Office Action Summary

10/733,649

WRIGHT ET AL.

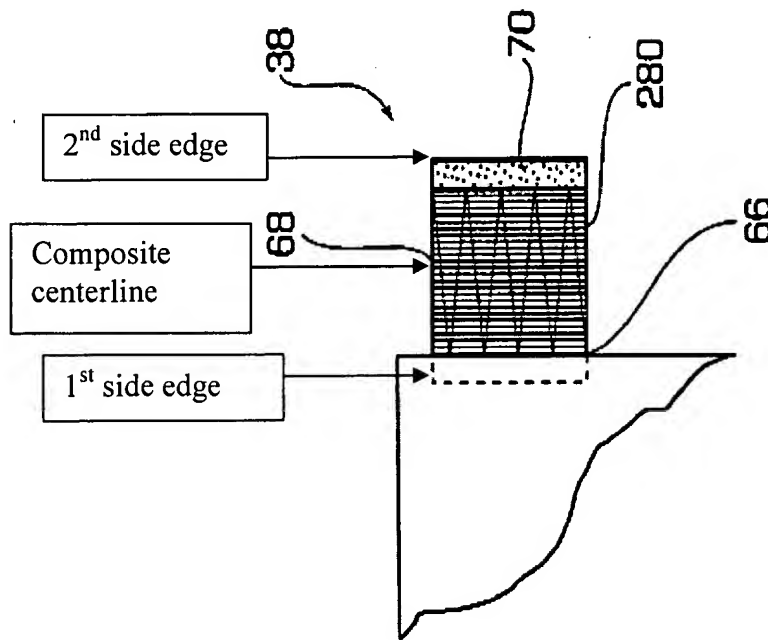
Regarding claim 57 Guevara teaches a disposable absorbent garment (20) comprising:

a topsheet (26);

a backsheet (28);

an absorbent core (30) disposed between said topsheet (26) and said backsheet (28) such that a longitudinal centerline of said garment (20) extends through said topsheet (26), said backsheet (28), and said absorbent core (30), wherein said topsheet (26), said backsheet (28) and said absorbent core (30) provide a central body (24) of said disposable absorbent garment (20); and

an elastic composite band (38) attached to said central body (24), said elastic composite band (38) having a first side edge attached to said central body (24), a second side edge, and a composite centerline extending in a direction extending continuously between, and in generally parallel relation with, said side edges, said elastic composite band (38) including a base layer and top layer and an elastic construction (280) disposed between the base layer and top layer and spaced inwardly from each said side edge; and

wherein said elastic construction (280) includes an arrangement of a plurality of spaced apart elastic elements (280) distributed in a direction extending between said side edges, each said elastic element being aligned in a nearly perpendicular relation with said composite centerline and spaced inwardly from said first side edge to form a non-elasticized region between

the first side edge and said elastic elements (280)(col. 10, lines 1-42)(see annotated fig. 3, and fig. 6A infra).

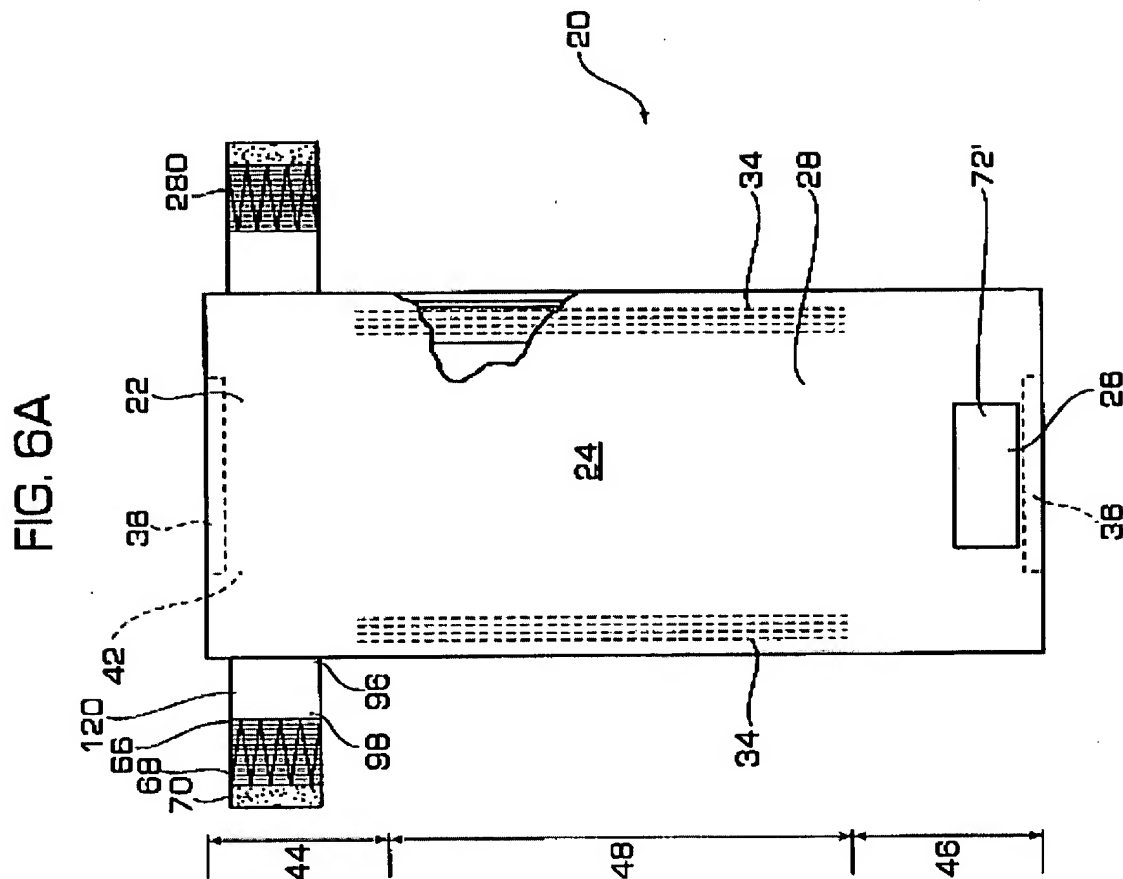
4. Guevara does not teach that that the elastic elements are generally perpendicular to the longitudinal centerline of the composite centerline. However, the do extend at a very obtuse or shallow angel that is almost 90° or perpendicular to the composite longitudinal centerline. Mere changes in shape are not sufficient to patentably distinguish an invention over the prior art. See *In re Dailey*, 357 F.2d 669, 149 USPQ 47 (CCPA 1966)(The court held that the configuration of the claimed disposable plastic nursing container was a matter of choice which a person of ordinary skill in the art would have found obvious absent persuasive evidence that the particular configuration of the claimed container was significant.). In the instant case, modifying the

reference's almost parallel elastic threads to be generally parallel elastic threads would not significantly change their stretch performance.

6. Regarding claims 60 and 61, see fig. 6A, *supra*.
